Re: Application of Kenneth Vario's special use permit - Stern St Jamestown

RE: Zoning Section 82-314: High Groundwater Table and Impervious Overlay District, **Sub-District A**
Kenneth Vario: AP 14, Lot 111; Pole #9, Stern Street, Jamestown, RI

RE: Kenneth Vario, Plat 14 Lot 111, Stern St.- Zoning
Ordinance Section 314 High Groundwater Table and
Impervious Overlay District Sub-district A review -
Recommendation to the Zoning Board

Re: Zoning Ordinance Section 314
High Groundwater Table and Impervious Overlay District
Sub-District A

- f. 200 Ft. Abutters List
 - g. RIDEM OWTS permit dated 2-27-15 and Plan dated 12-20-14
 - h. Site Plan titled “Town Submission for Kenneth Vario” dated 3-2-15

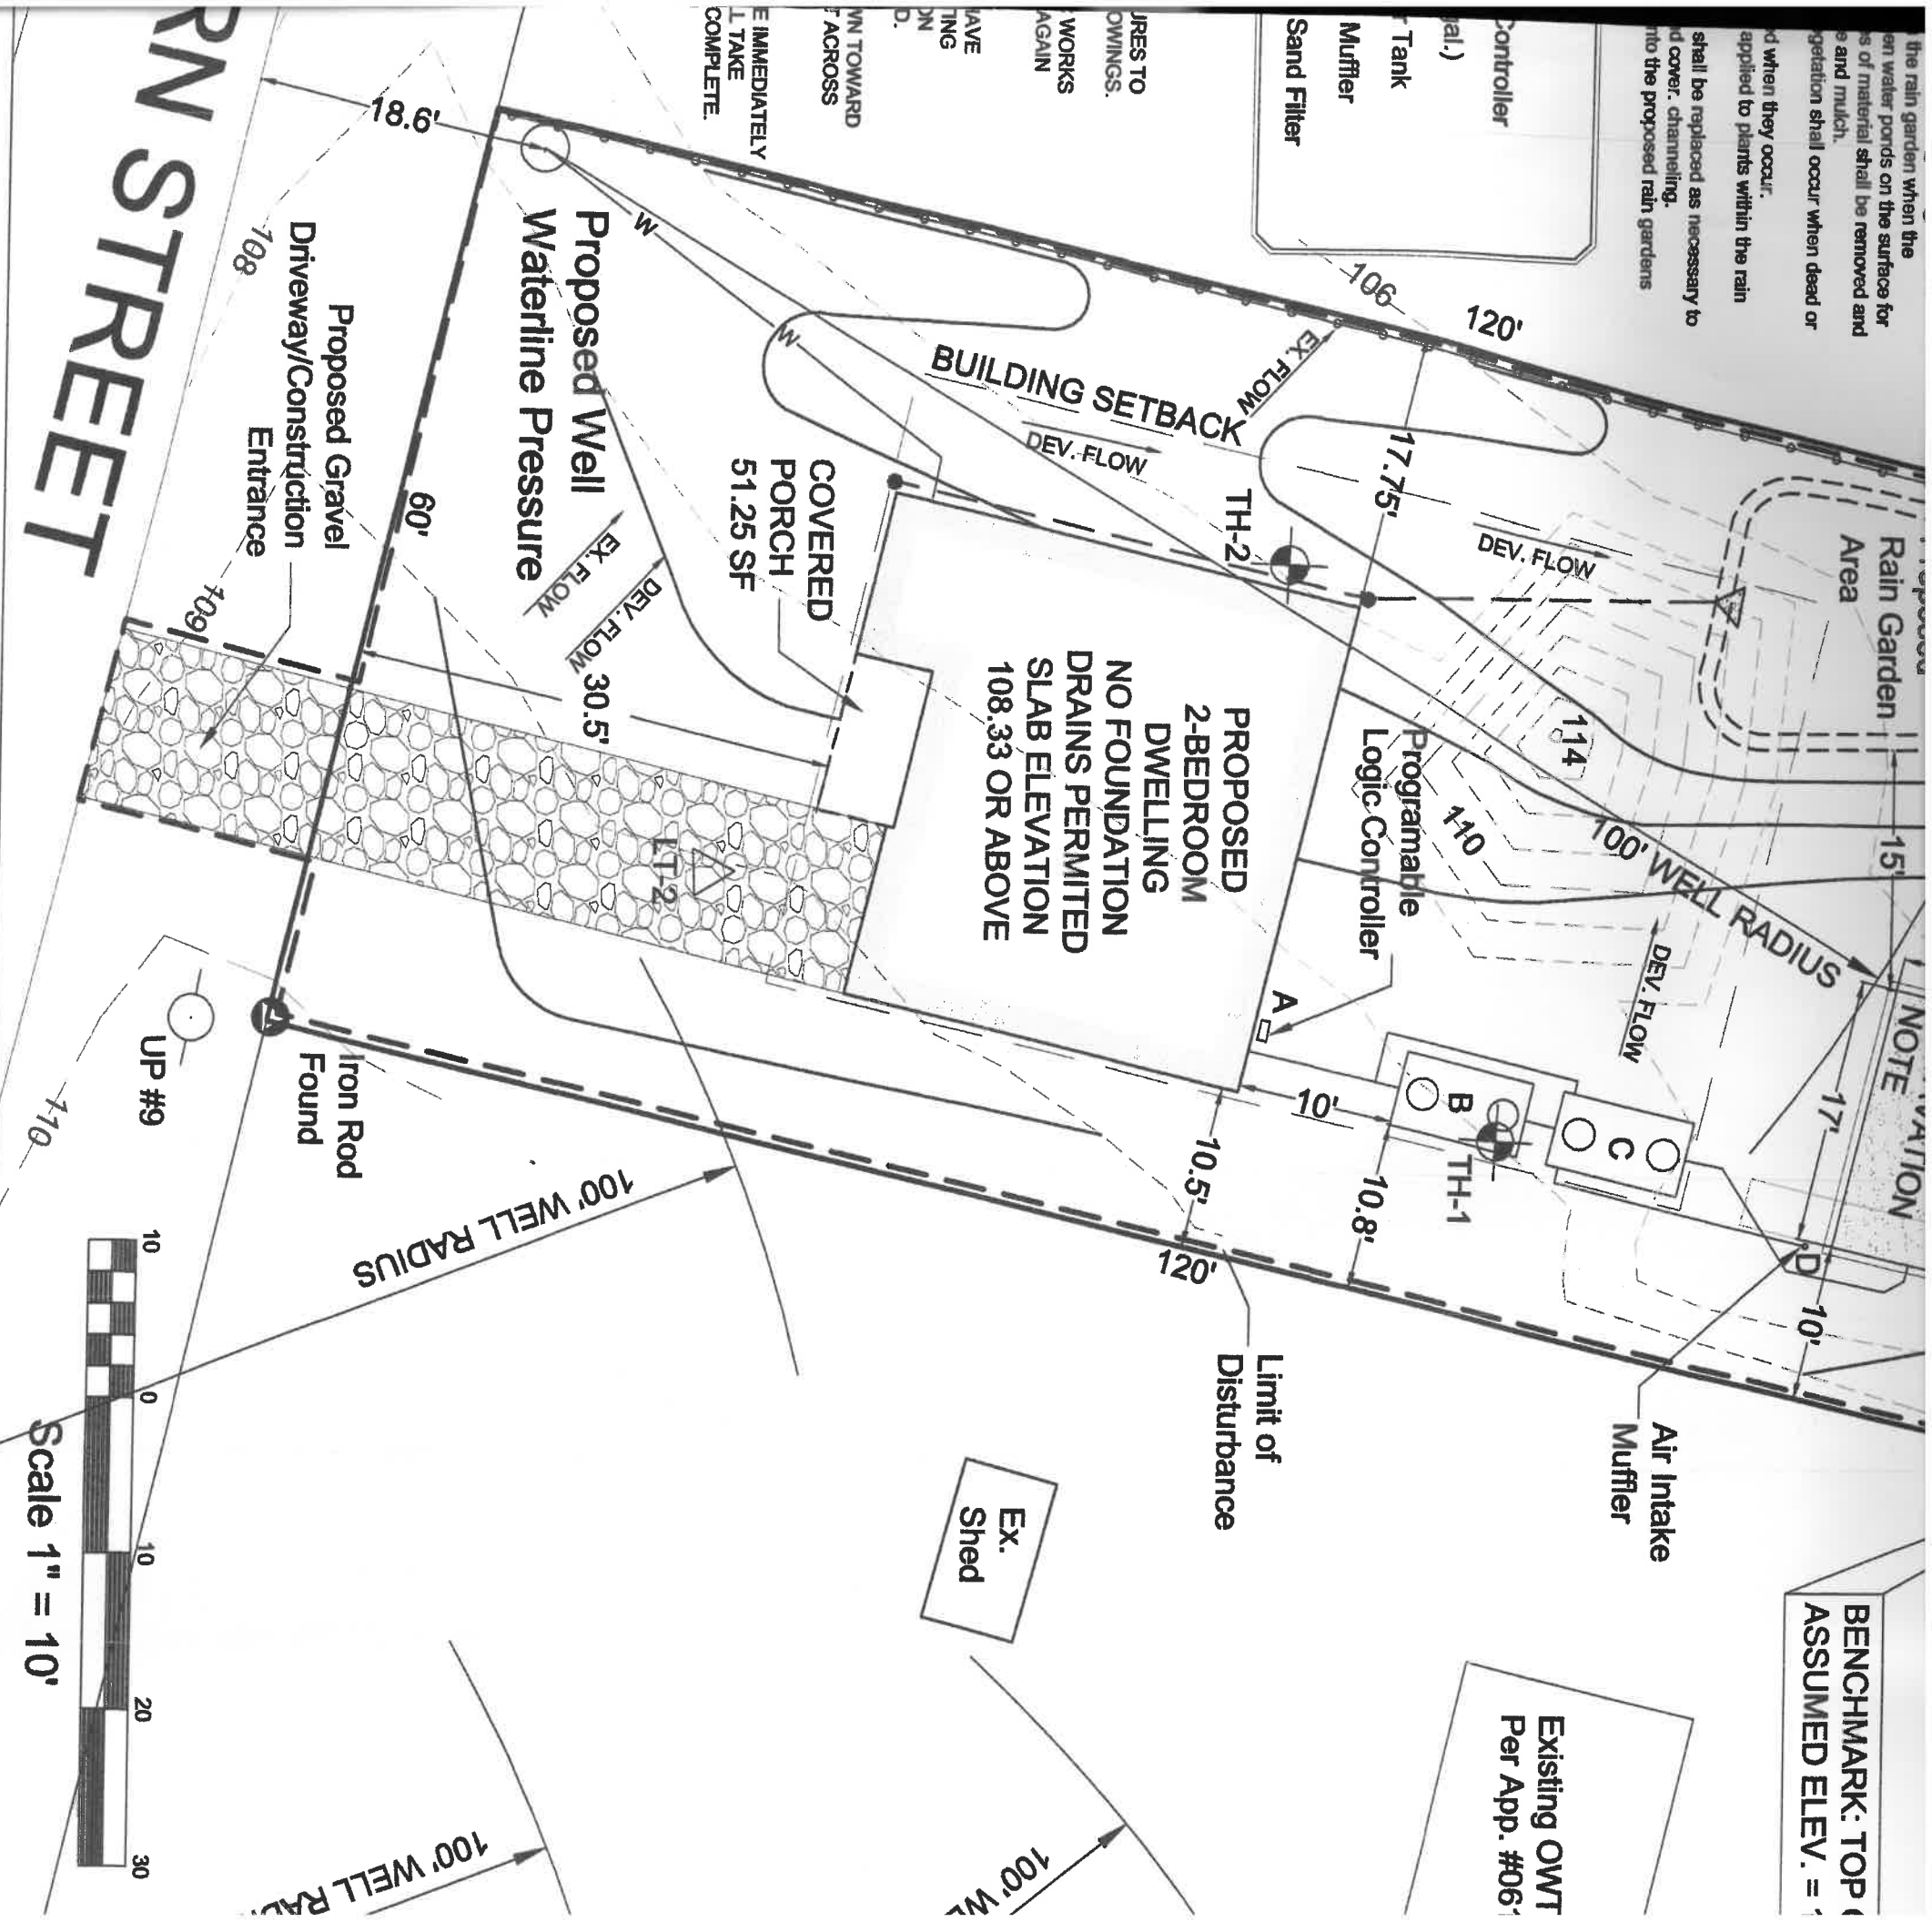
We are in receipt of plans and drainage analysis prepared by American Engineering, Inc. The applicant is proposing to build a 2-bedroom dwelling on the above referenced 7,200 SF vacant lot. The soil evaluation reports provided indicate that the depth to seasonal high groundwater is 24" and 24" to Category 9 soils, placing this application in sub-district A.

The applicant is not proposing any fill on the lot. Proposed grading will direct runoff to the rain garden at the north western corner of the property and preserve the pre-development runoff patterns.

The applicant is proposing 11.9% of the total lot coverage, which meets the 12% allowable impervious cover limit under the Ordinance.

The proposed 2-bedroom Septi-Tech onsite wastewater treatment system and bottomless sand filter leachfield approved by RIDEM on 2-27-2015 (App #9715-2882) provides for advanced

treatment, and meets the requirements of this ordinance. A 2-bedroom deed restriction is required for this lot. This lot had received previous approval for a Conventional OWTS on 05-14-1998. The excavation for the leachfield started in 2001 but was never completed and a mound of soil from the excavation still exists onsite and can be seen in the photo at the end of this memo.

In order to mitigate the increase in runoff from the proposed improvements, the applicant has proposed a rain garden totaling 403 C.F. The proposed rain garden exceeds the criteria of the Ordinance to accommodate the increase in runoff for a 10-year storm. The applicant is only proposing 6" of separation between the bottom of rain garden and the seasonal high groundwater table. The Town typically requires 12" of separation to seasonal high groundwater. However, doing so in this case would lead to more significant fill and grading on the lot.

The application meets the requirement of the High Groundwater and Impervious Layer Ordinance. However, we recommend the contractor take additional erosion and sediment control measures to ensure that the existing mound of soil from the previous leachfield excavation does not erode from the site and affect abutting lots.
